SUBJ: **Addendum 1 – Clarifications to the Specifications and Responses to Vendor's Questions**

BID ITEM: **Bid Item #23-150 Construction - Airfield Electrical System Upgrade for Runways 5-23 & 11-29 for Augusta, GA – Daniel Field Airport**

ADDENDUM NO. 1

AIRFIELD LIGHTING & WIRING PLAN - EXISTING AWOS & WINDCONE
E8
 Sheet 02 of 02

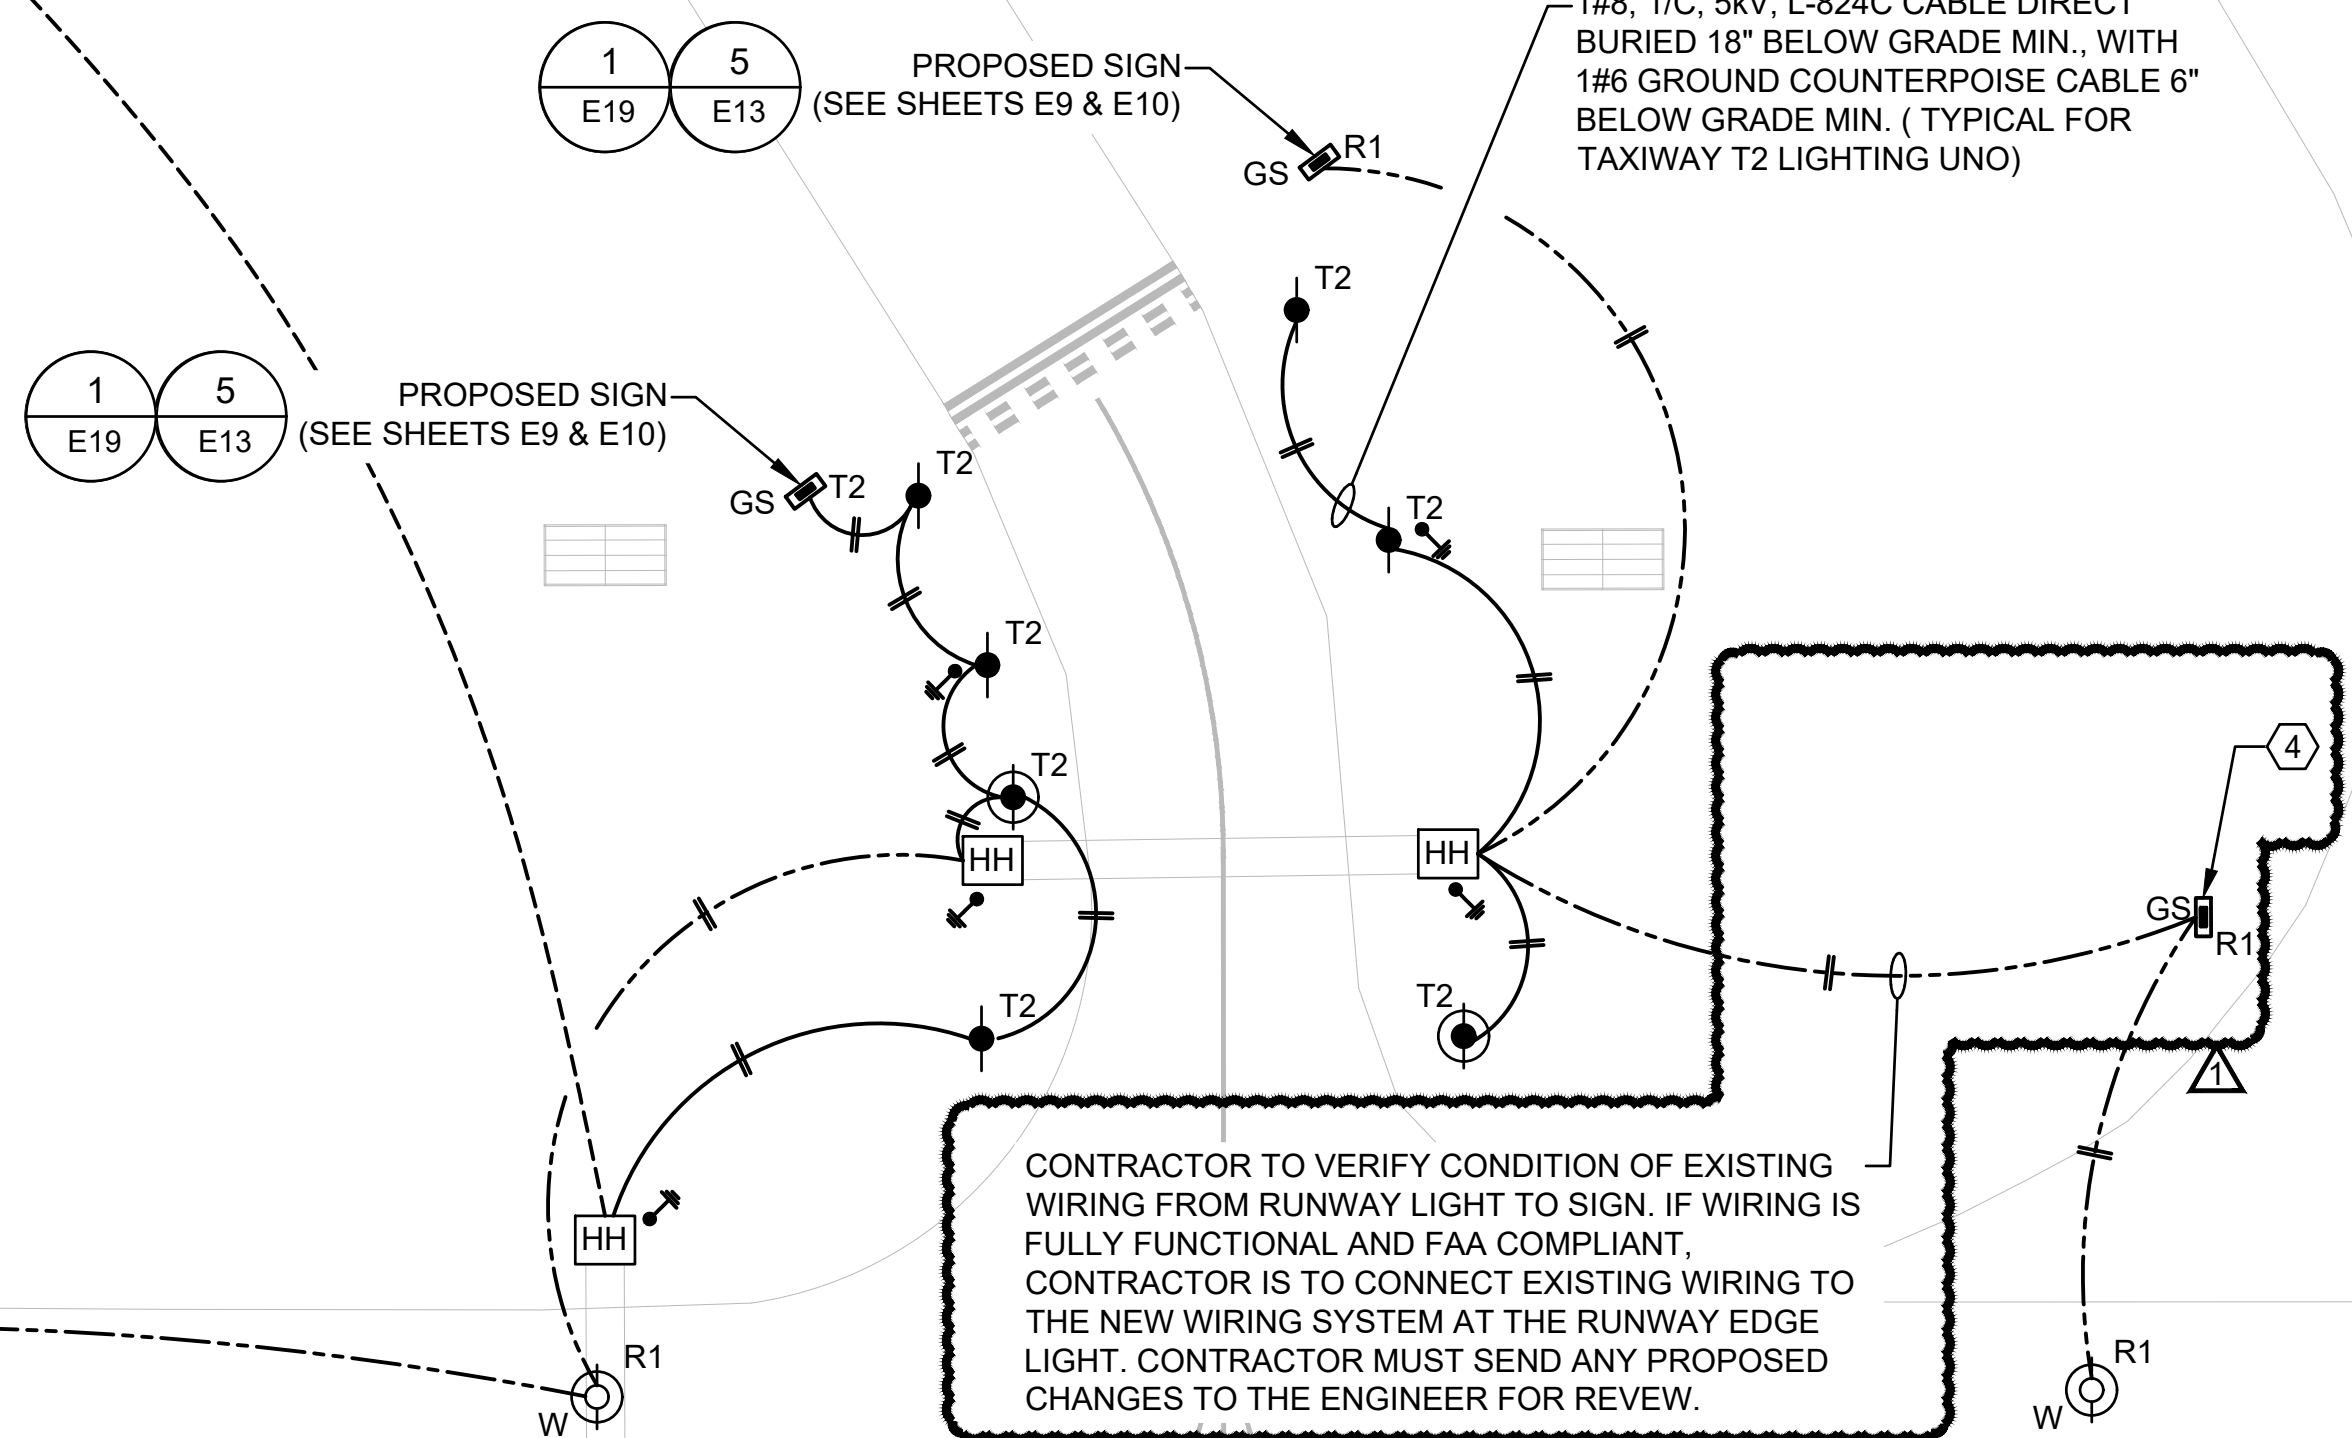
- R. **Replace Sheet E8** – Airfield Lighting & Wiring Plan – Existing AWOS System with revised Sheet E8 attached to this Addendum 1.
- Scale of this sheet revised from 1"-50' to 1"-25'.

- Deleted all Field Lighting Arrestors.
 - Keynote 4 revised to state Existing Sign to remain. Connect to new wiring system as required.
 - Mandatory sign 11-29 (S22) revised from being replaced to existing to remain.

- Revised Keynote 1 & 2: Cable size for Wind cone Circuit revised from #4/0, 1#4/0(G) – 2"C to #12, 1#12(G) – 1" C.
- S. **Replace Sheet E9** – Airfield Sign Chart Plan – Runway 5/23 with revised Sheet E9 attached to this Addendum 1.

SIGN CHART			
S1	5	S16	NOT USED
S2	D→	S17	11-29 1-23
S3	5-23	S18	
S4	← TERM	S19	D→
S5	← E	S20	23
S6	C→	S21	NOT USED
S7	5-23	S22	NOT USED
S8	INSURV 10	S23	6-22 A
S9	← C	S24	TERM
S10	A→	S25	62-5 11-29
S11	5-23		
S12	TER→		
S13	← TER		
S14	NOT USED		
S15	11-29

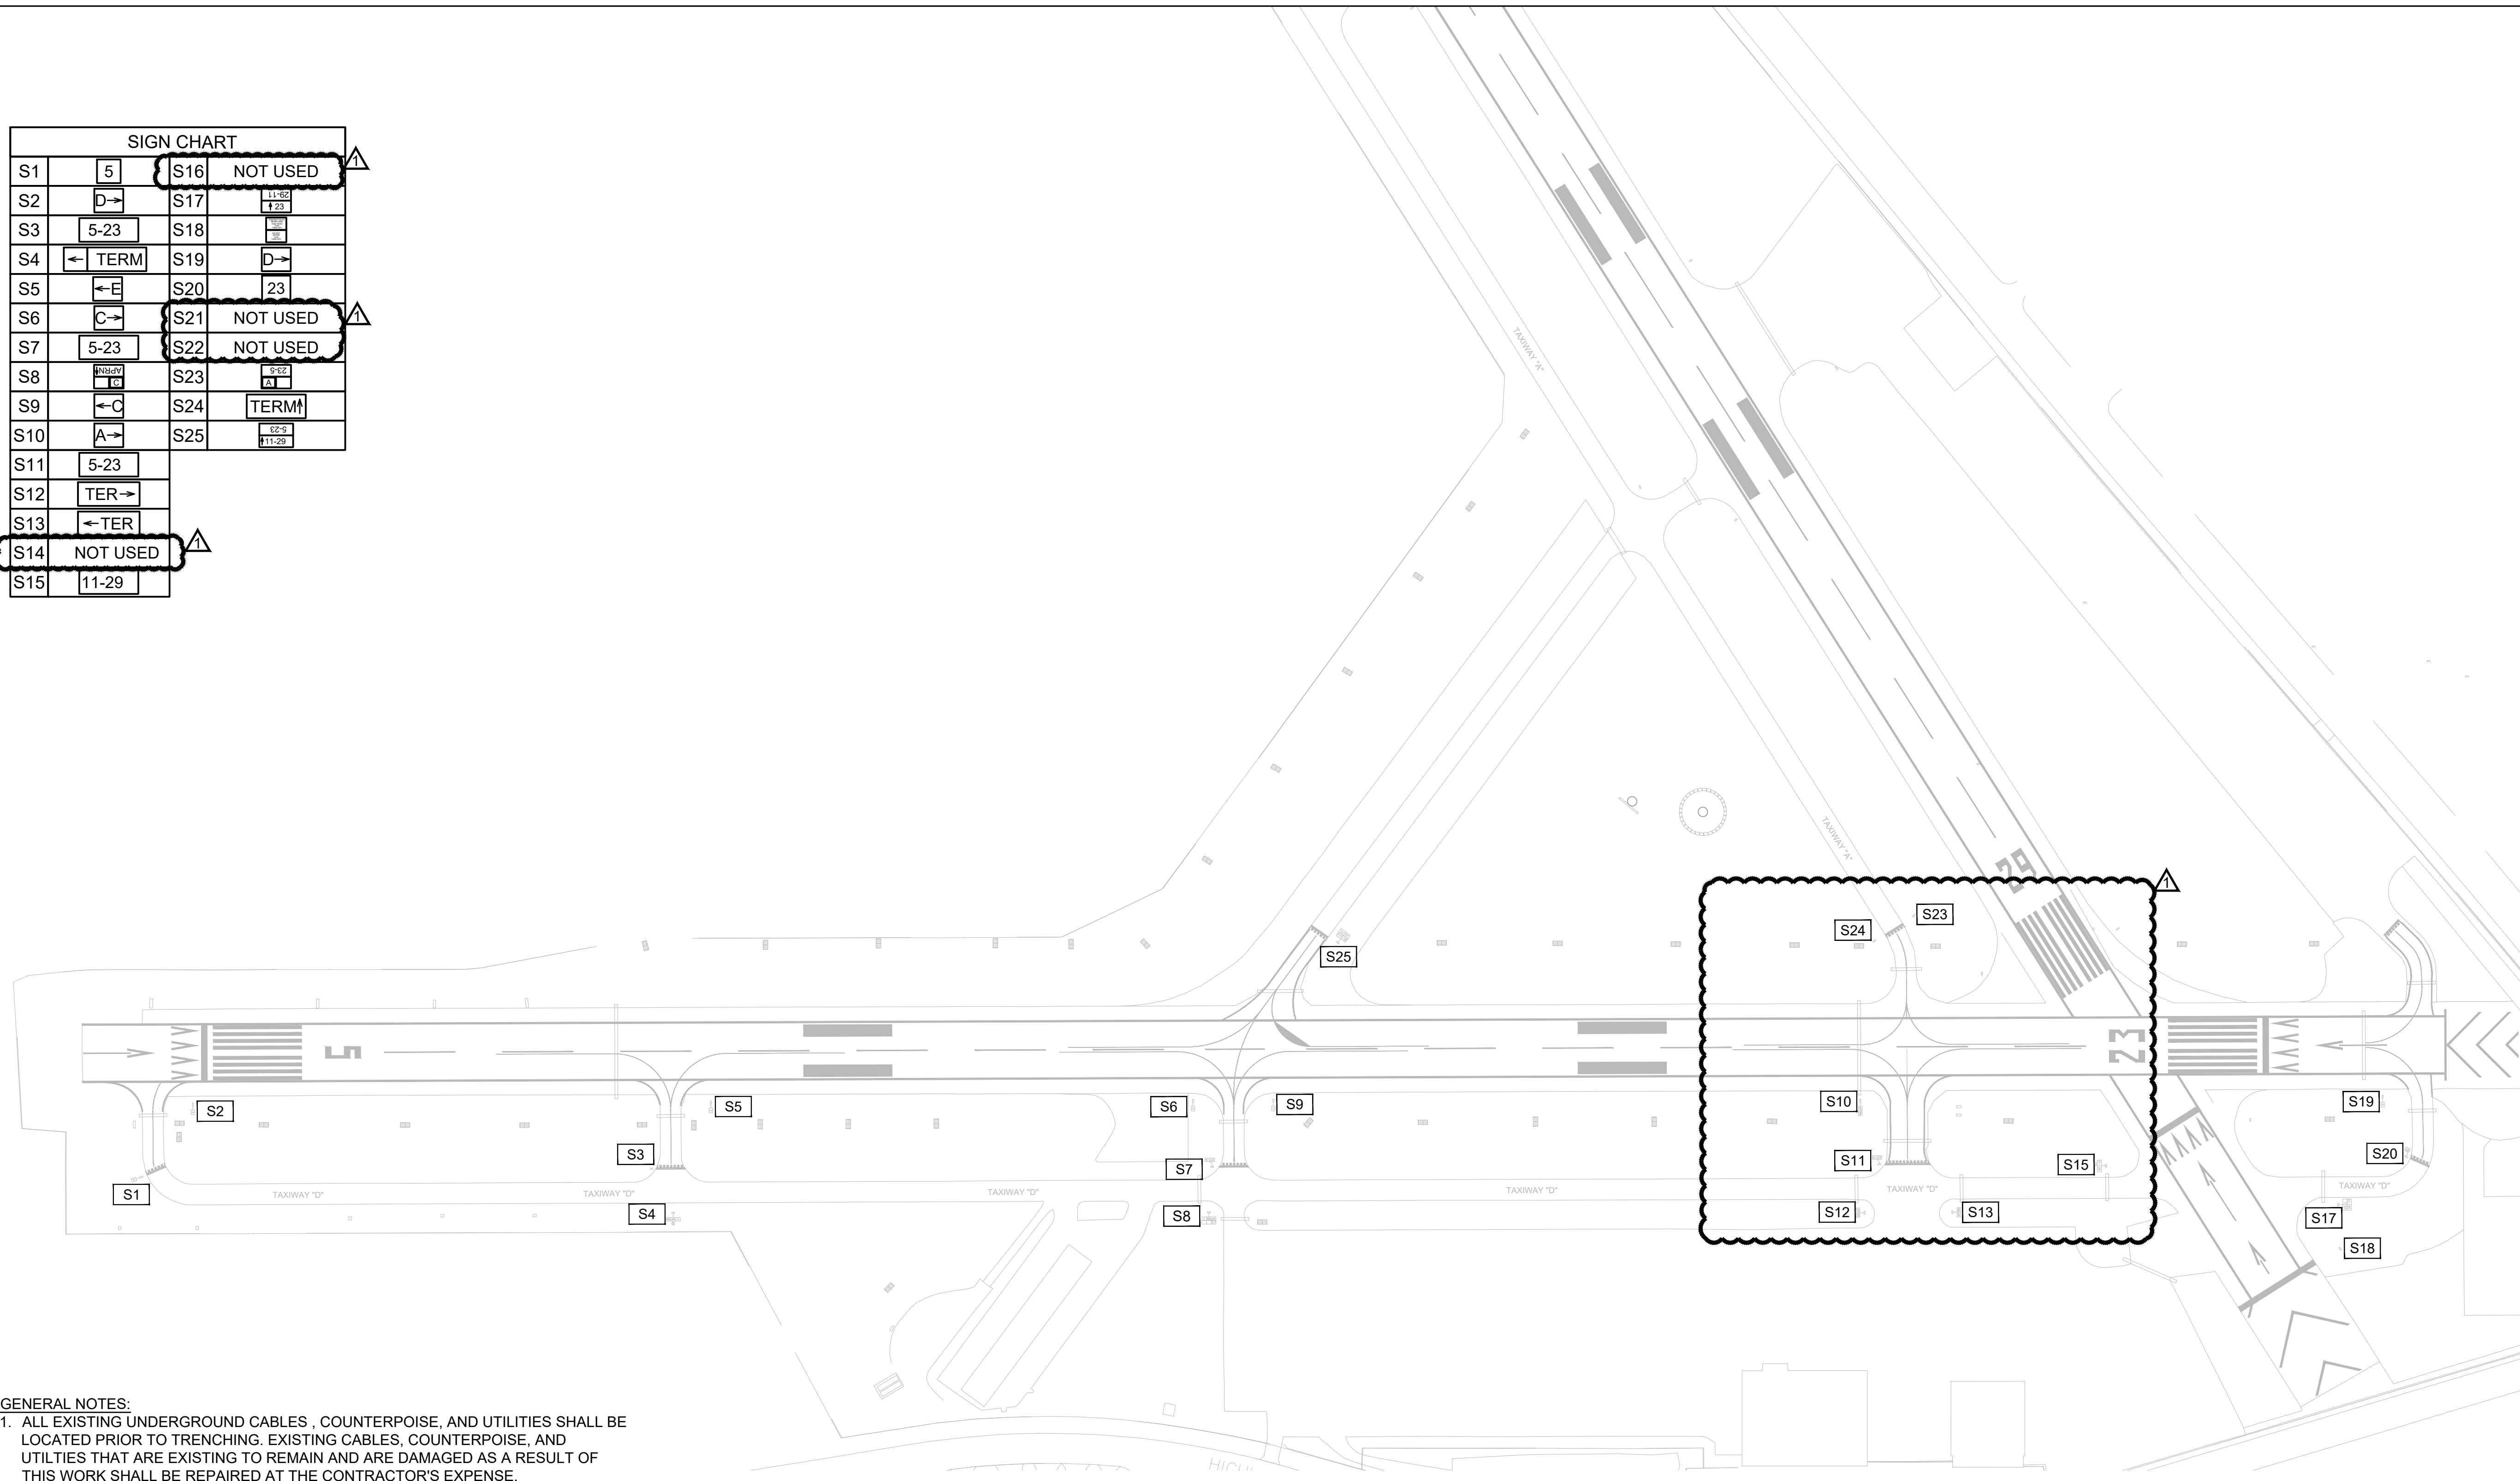
- Scale of this sheet revised from 1"-300' to 1"-150'.
 - Mandatory Signs S14; S16; S21-S22 revised to not used on sign chart and have been deleted from the sheet.

2. On Plan E9, General note 4, states, “Contractor shall stake the location of all proposed signs for review by the RPR prior to installation.”

- a. Question: Are we to assume the RPR will be responsible to staking control points for all edge lights, PAPI lights and REIL lights?

- b. Question: Are we also to assume that the RPR Engineer will NOT be staking the indicator signs?

Response: No. GMC will provide all survey datum/control and AutoCAD files for contractor use.

Response: RPR/Engineer will not be performing any staking for the project. Contractor is responsible for staking the locations as stated in General note 4 on Plan E9.

**AIRFIELD SIGN
 LAYOUT PLAN
 - RUNWAY 5-23**

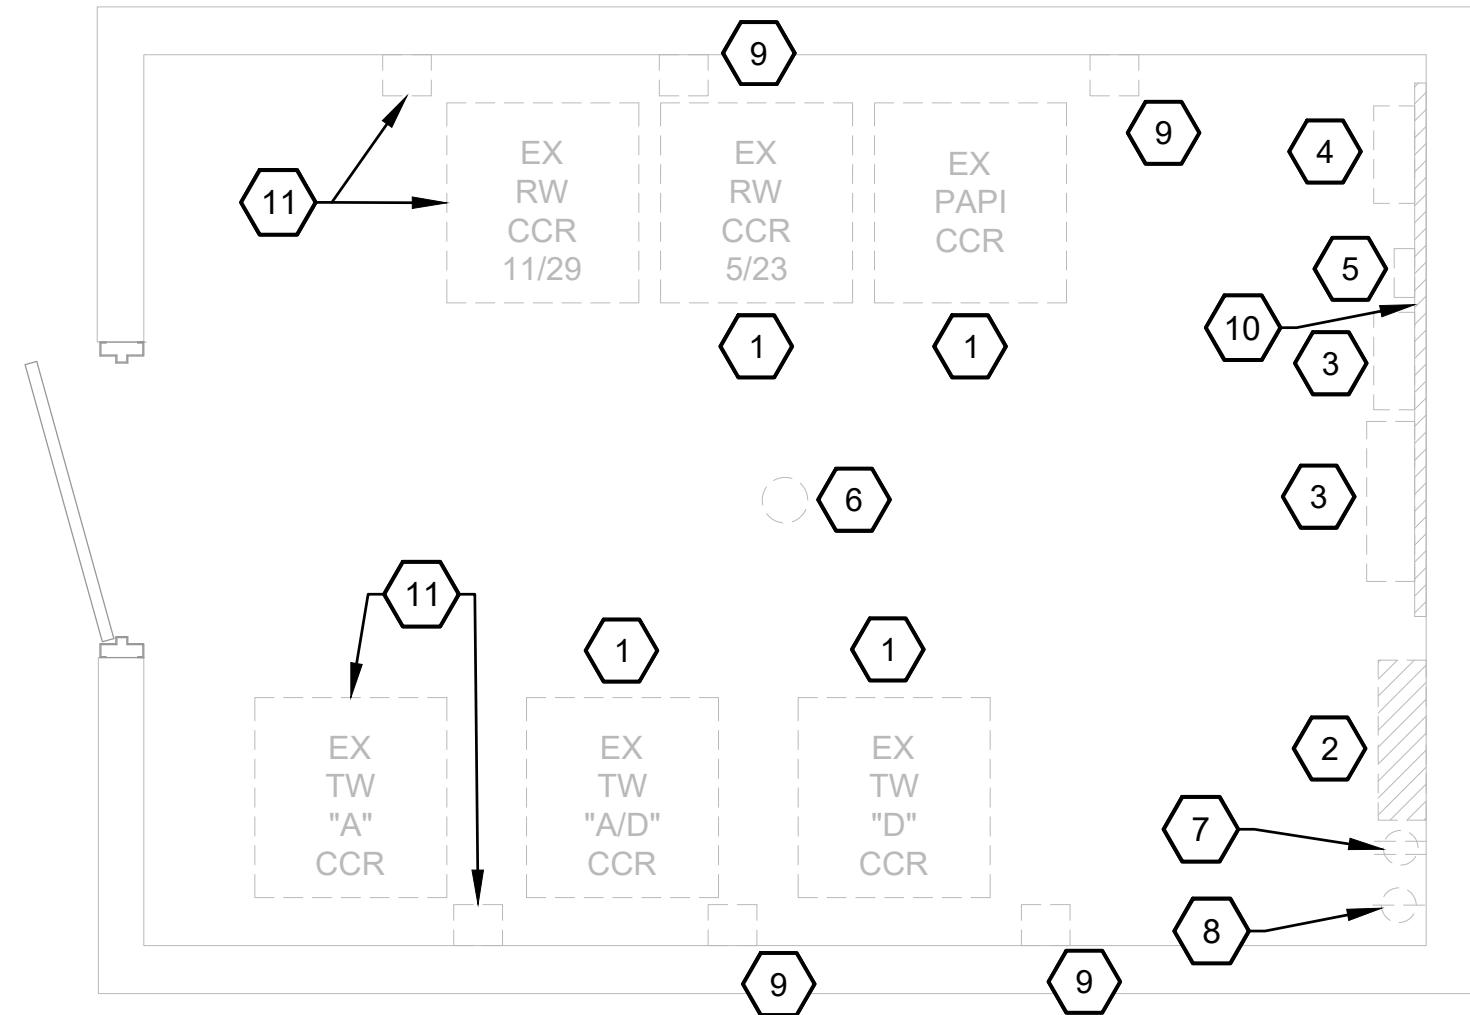
- T. **Replace Sheet E10** – Airfield Sign Layout Plan – Runway 5/23 with revised Sheet E9 attached to this Addendum 1.
- Scale of this sheet revised from 1"-300' to 1"-150'.

- Mandatory Signs S14; S16; S21-S22 have been deleted from the sheet.
- U. **Replace Sheet E11** – Electrical Vault Plan with revised Sheet E11 attached to this Addendum 1.
